PROJECT NAME: HARDBERGER PARK PHASE 4 (PARKING LOT)

DATE: 7/30/15

**ADDENDUM NO.1**

TCI PROJECT NO.: 40-00430A

HARDBERGER PARK SAN ANTONIO, TEXAS HARDBERGER PARK PHASE IV Electrical Riser and Details

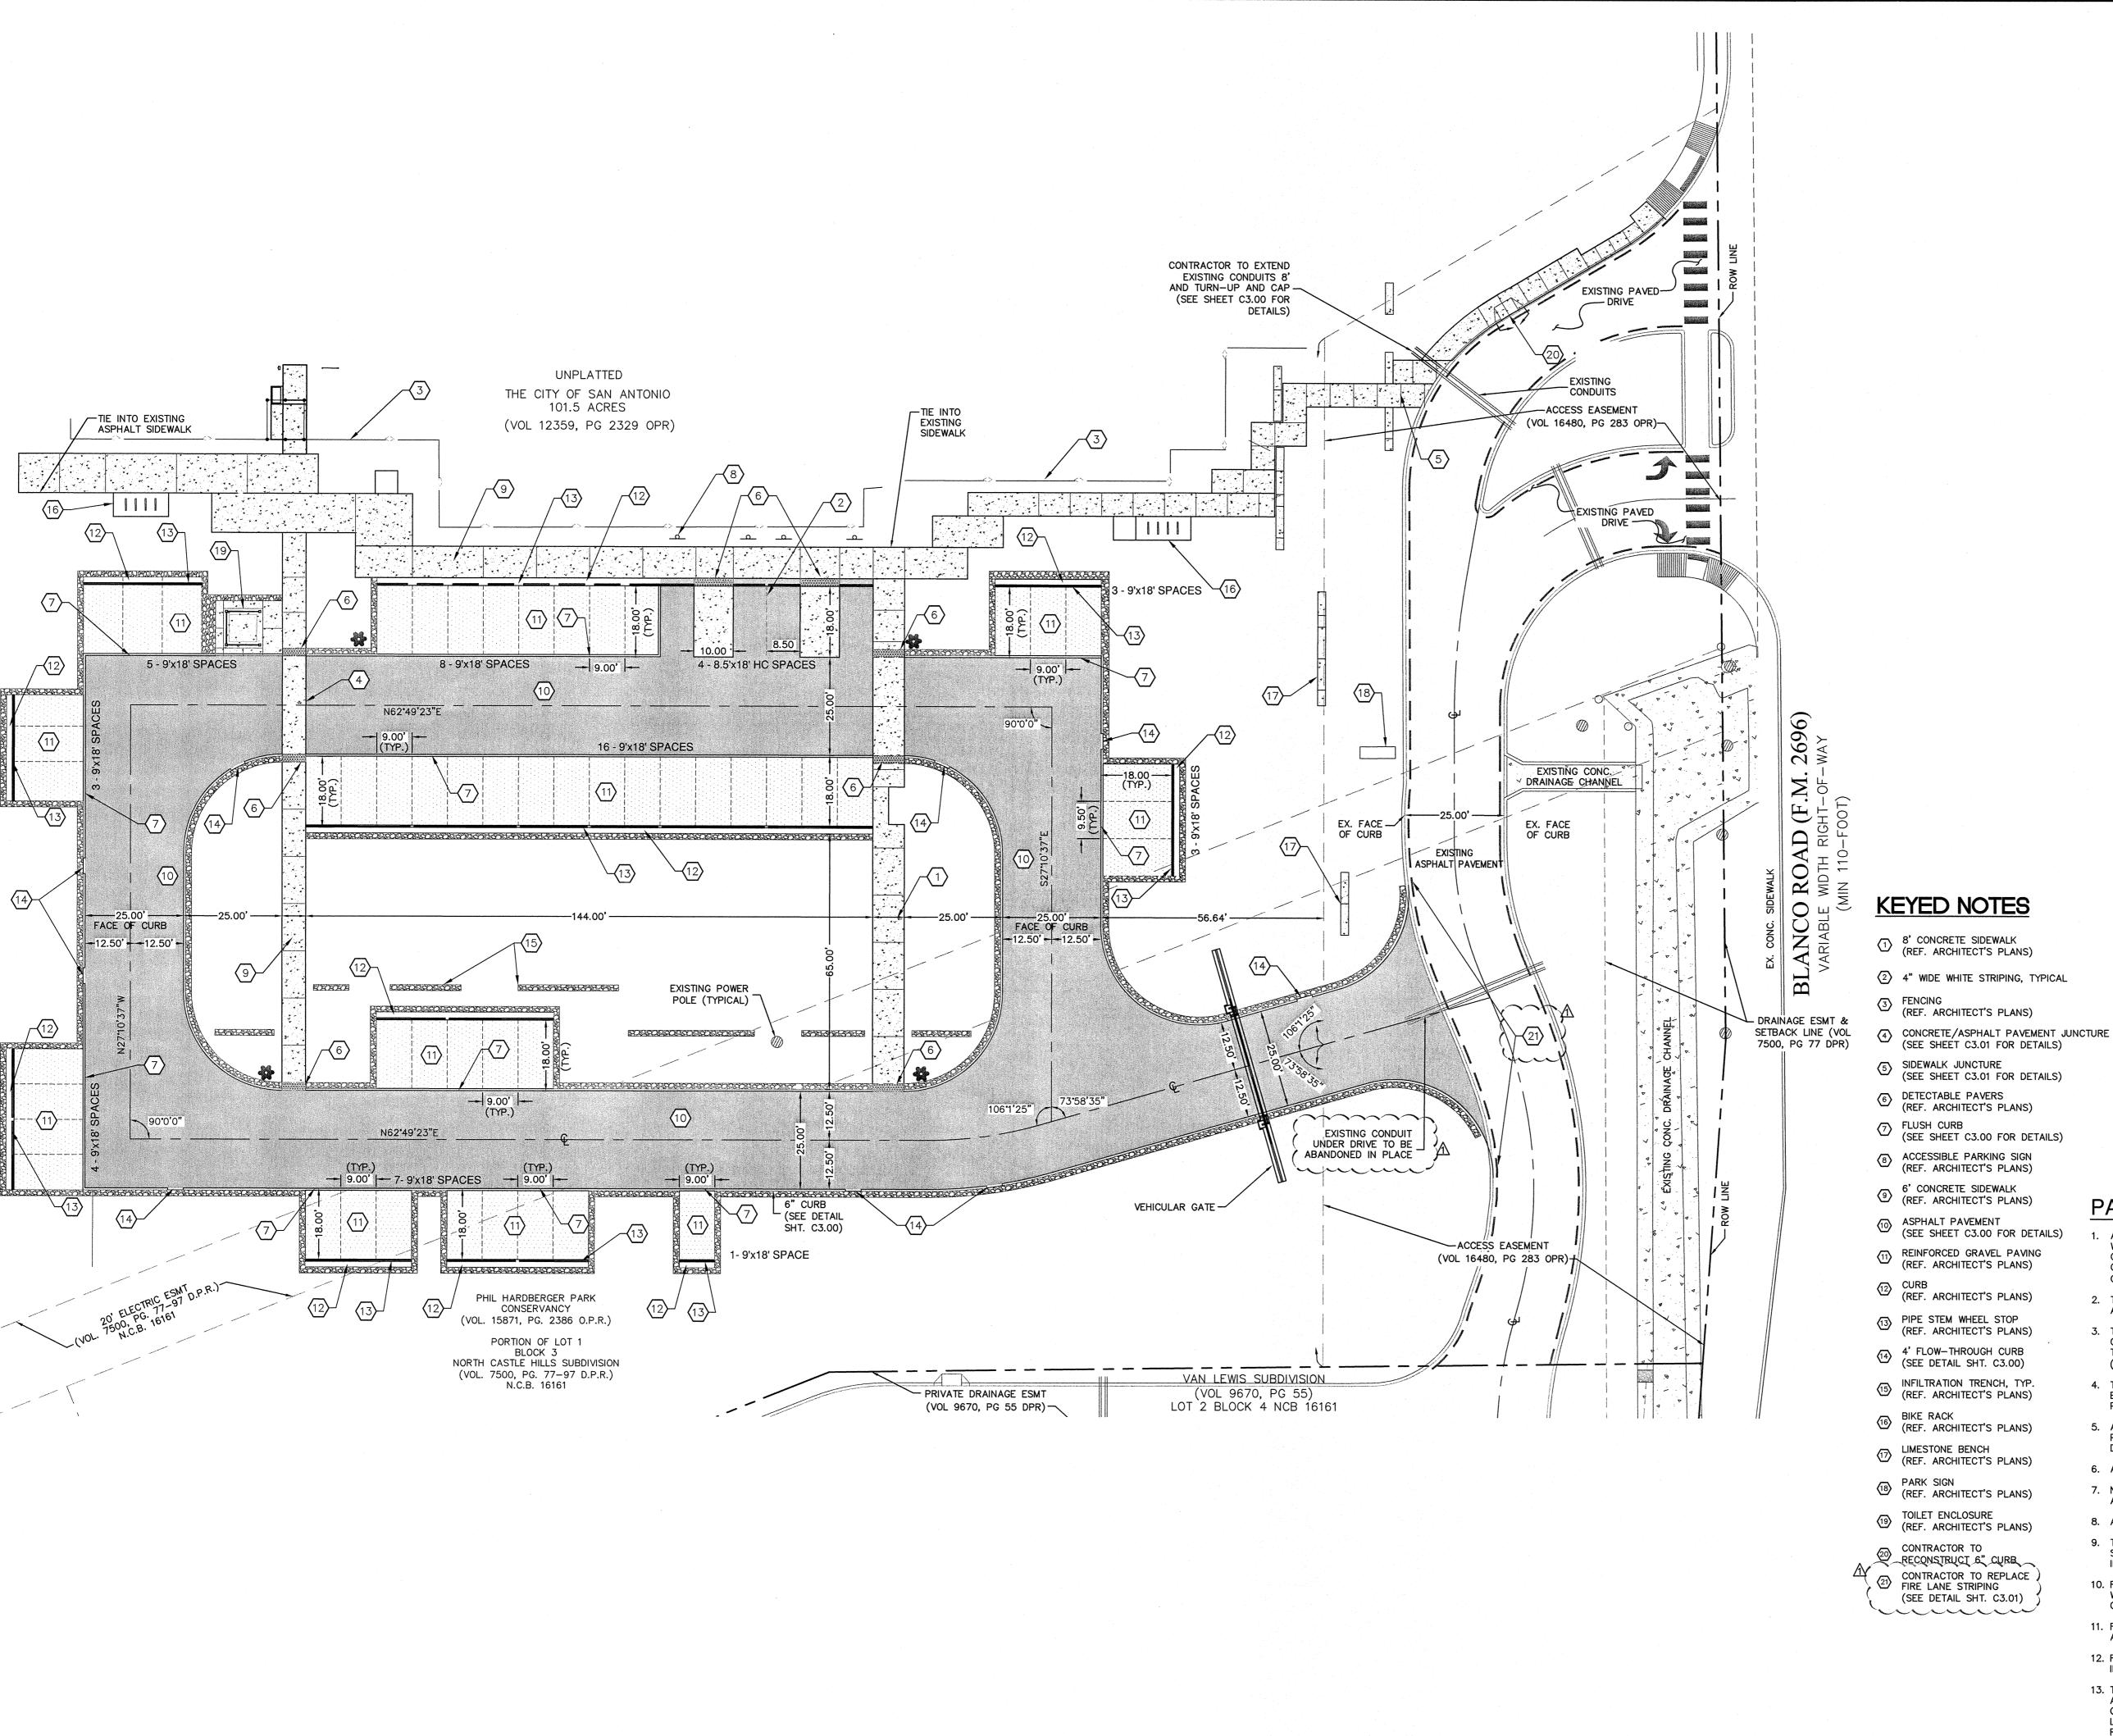
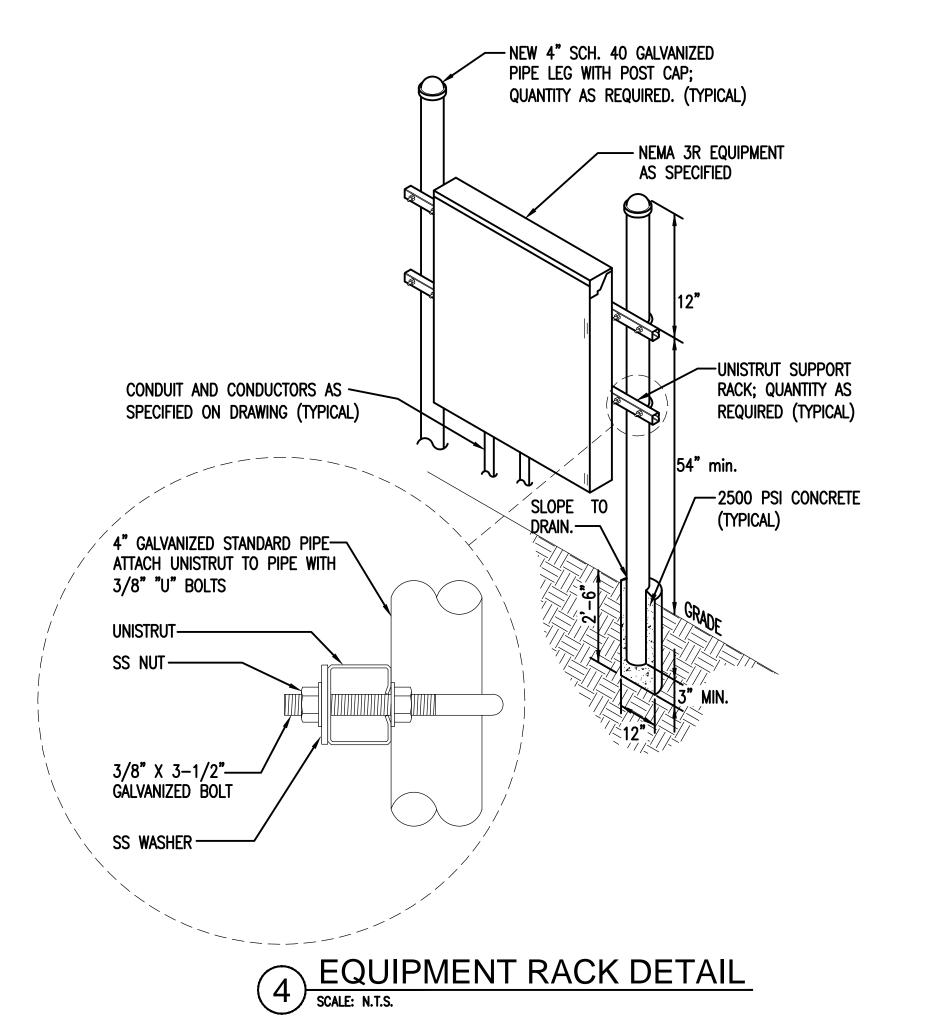
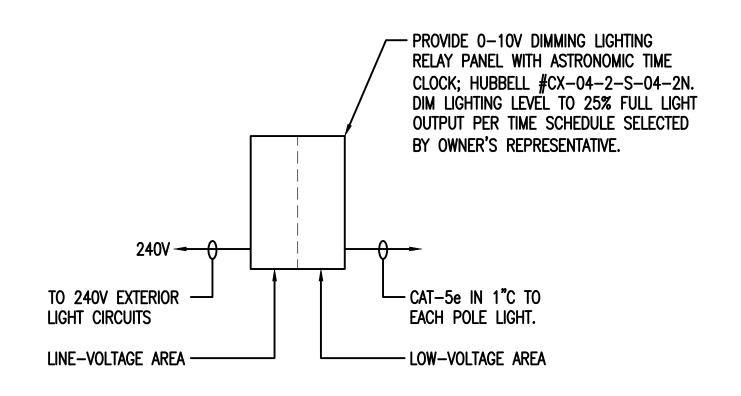
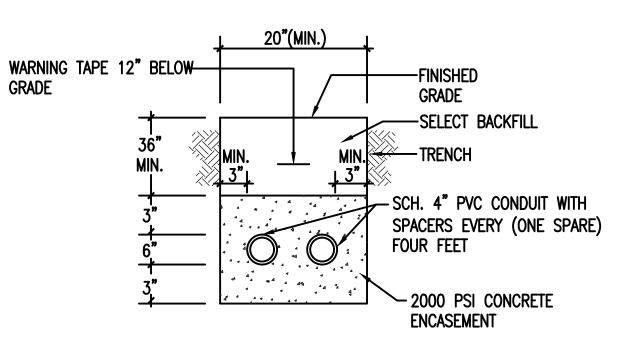
• Replace and utilize the revised electrical drawings E100, E200, and E300. The previous pole mounted transformer configuration has been replaced with a CPS padmount transformer and underground primary distribution duct bank.

CHECKED JD DRAWN TL SHEET C2.00

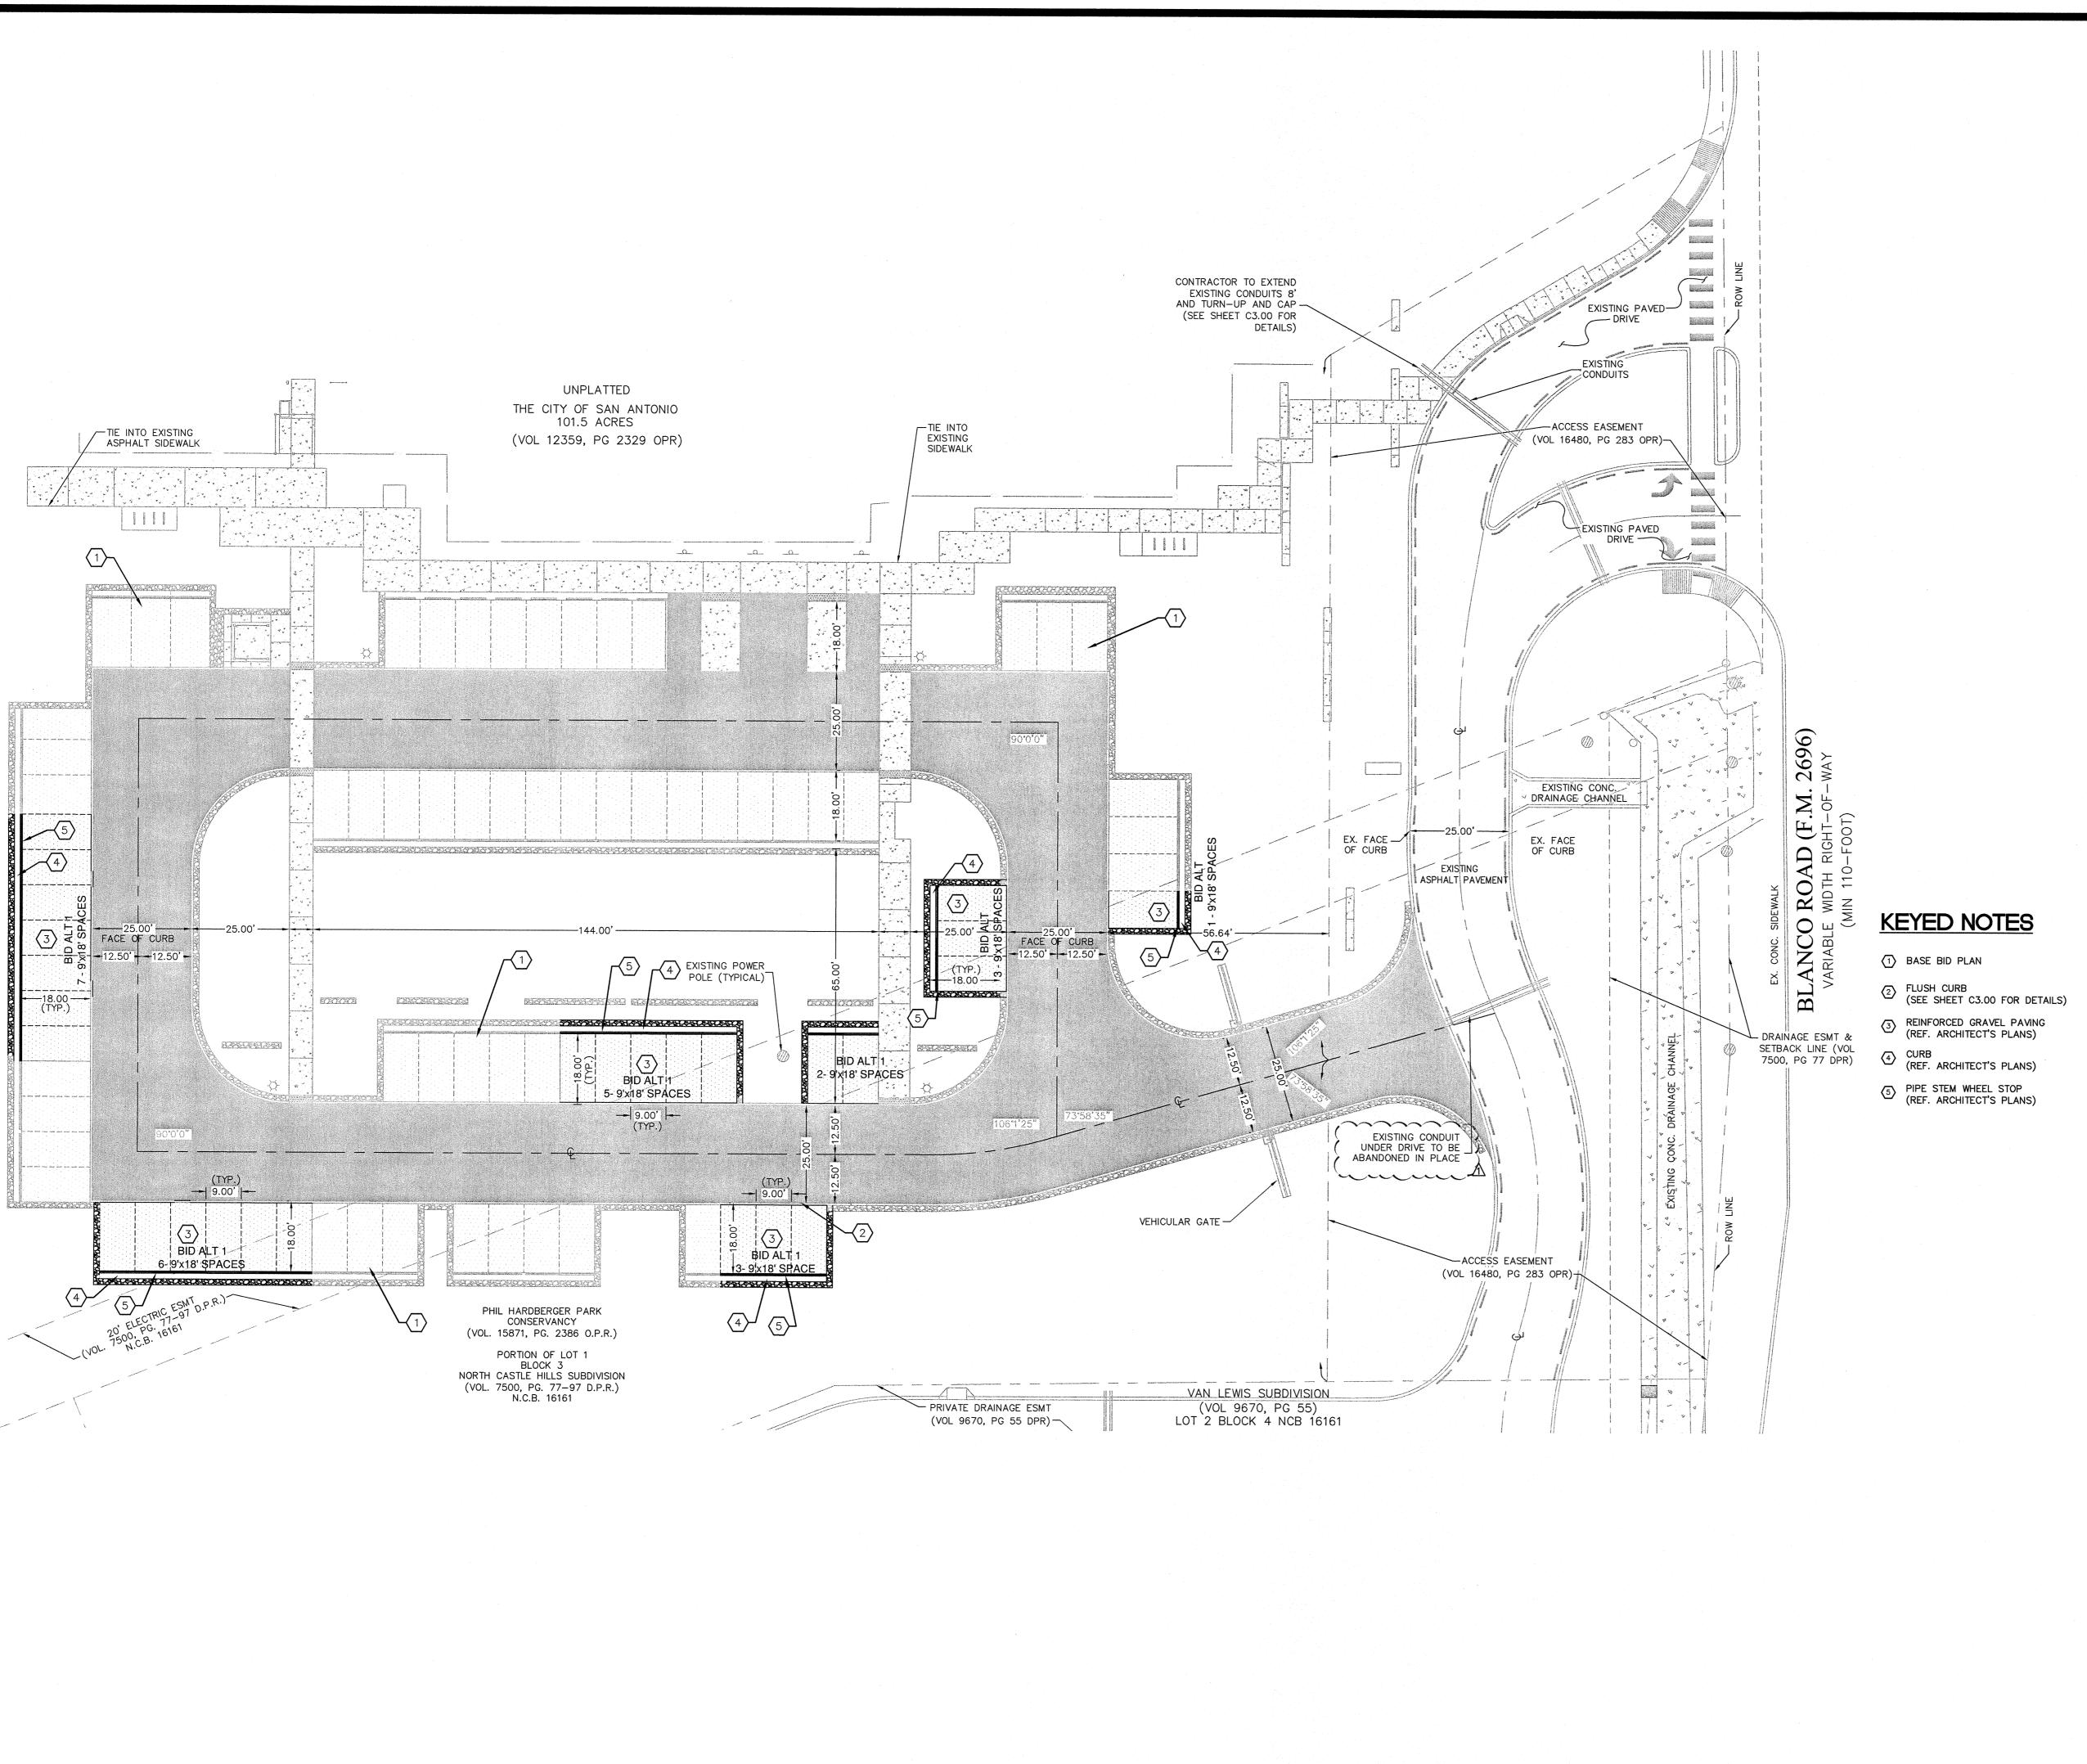
- Replace and utilize the revised civil drawings C2.00 and C2.00A. Revisions are described below:
  - The fire lane striping of the existing asphalt access driveway from Blanco Road was recently painted. This striping is now shown as existing and a note has been added to the plans for the portion of striping that will need to be replaced for the construction of the parking lot driveway.
  - The existing conduit under the drive will be abandoned in place. A note has been added to sheet C2.00.
